PD Modification Application: MM 25-0745

Development Services Department

1.0 APPLICATION SUMMARY

APPLICATION NUMBER: MM 25-0745

2.5 Proposed Site Plan (partial provided below for size and orientation purposes. See Section 8.2 for full site plan)

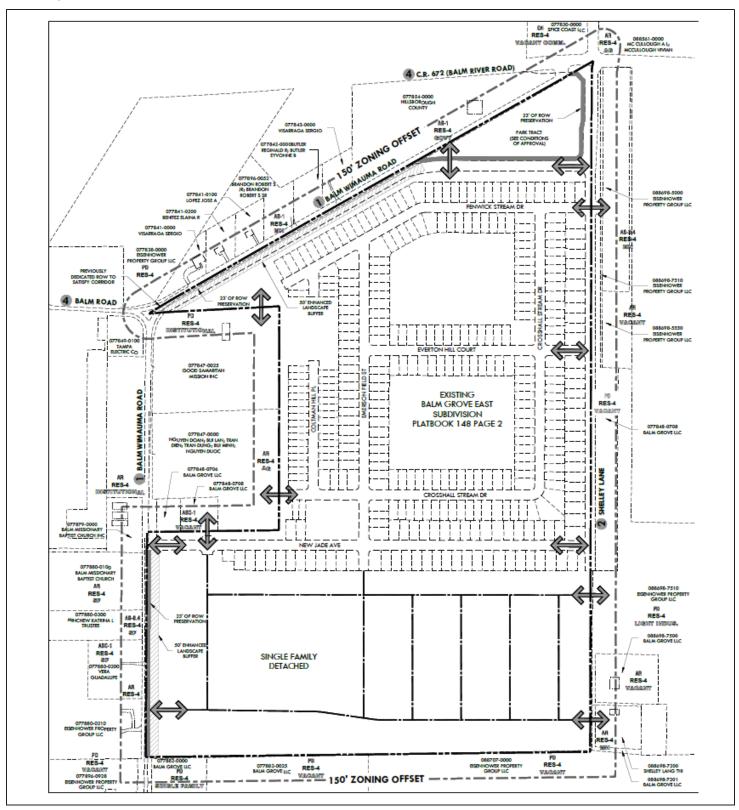
1. Site plan to delineate 50-foot wide buffer in areas previously approved – the Grove Parcel.
